1R - 482

**RE: Penrose Federal Lease Battery #1  
Unit F, Section 9, Township 22S, Range 37E, Lea County, New Mexico  
OCD Case #1R0482**

The New Mexico Oil Conservation Division (OCD) has reviewed the investigation report for the above referenced site submitted by Larson & Associates, Inc. on behalf of the John H. Hendrix Corp on January 10, 2007. The OCD has the following comments regarding the report:

**Re: Investigation Report of Historic Contamination and Remediation Plan, John H. Hendrix Corporation, Penrose Federal Lease, Battery #1, Unit C (NE/4, NW/4), Section 9, Township 22 South, Range 37 East, Lea County, New Mexico**

FIGURE #2

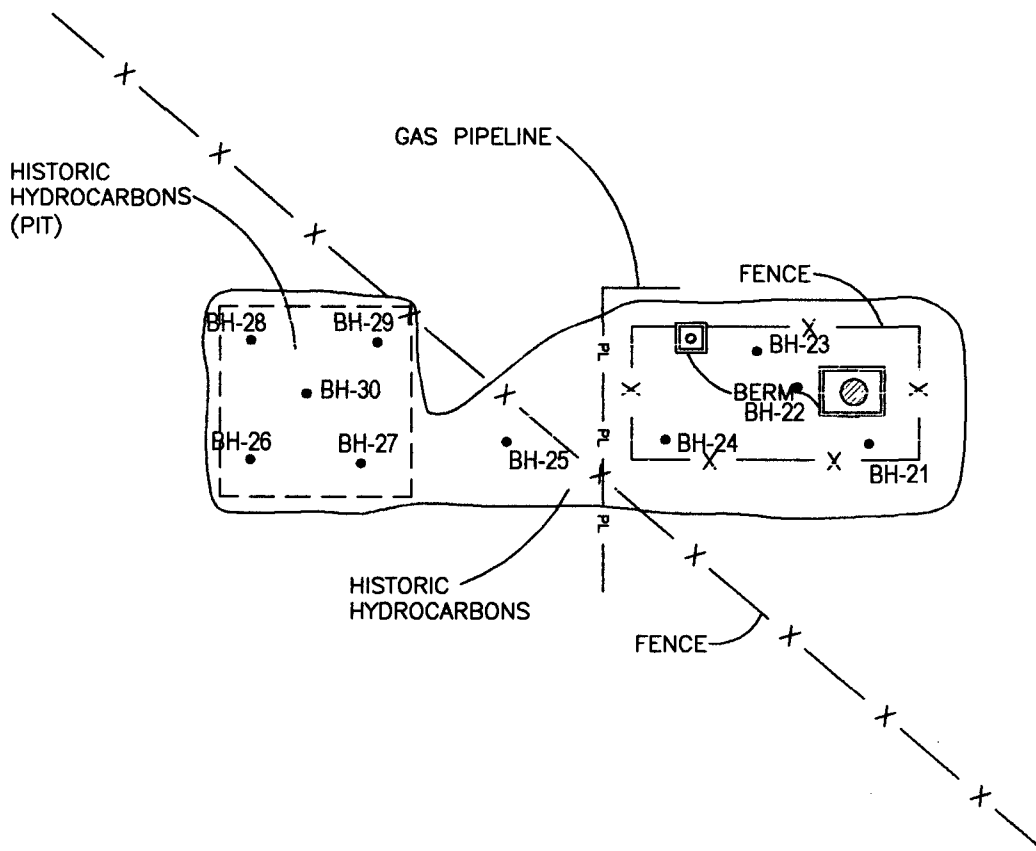
You note in the cover letter that the site is in Unit C of Sec. 9, T22S, R37E, but the map indicates that the site is in Unit E (the Lat/Lon indicates Unit F). Also, in Fig. #2 the legend notes the the site is in Unit F.  
In addition, in Appendix D the photo of the sign for the site reads "Unit F".

Ed: After reviewing your comments, I compared the GPS coordinates that were referenced in each of the above-referenced reports to the GPS readings I obtained for each of the borings. I found the GPS readings for the Elliott B-9, Battery #2 and #3 (N32 degrees, 24' 42.4" and W103 Degrees 10' 31.1") to be correct. The correct unit for the Elliott B-9, Battery #2 and #3 is "D". I found the GPS reading for the Elliott B-9, Battery #1, #4 and #5 and the Penrose Federal Battery to be incorrect. The correct GPS readings for the Elliott B-9, Battery #1, #4 and #5 should be N32 Degrees 24' 39.3", W103 Degrees 10' 12.4", which places this site in unit "C". The correct GPS readings for the Penrose Federal Battery are N32 Degrees 24' 32.2" and W103 Degrees 10' 14.7", which places this site in unit "F". The field and laboratory data is correct for each site, but I will revise the reports accordingly for the correct lat/long (i.e., text, drawings and photo pages). I apologize for the confusion. Would you like me to send you revised reports or affected pages only?
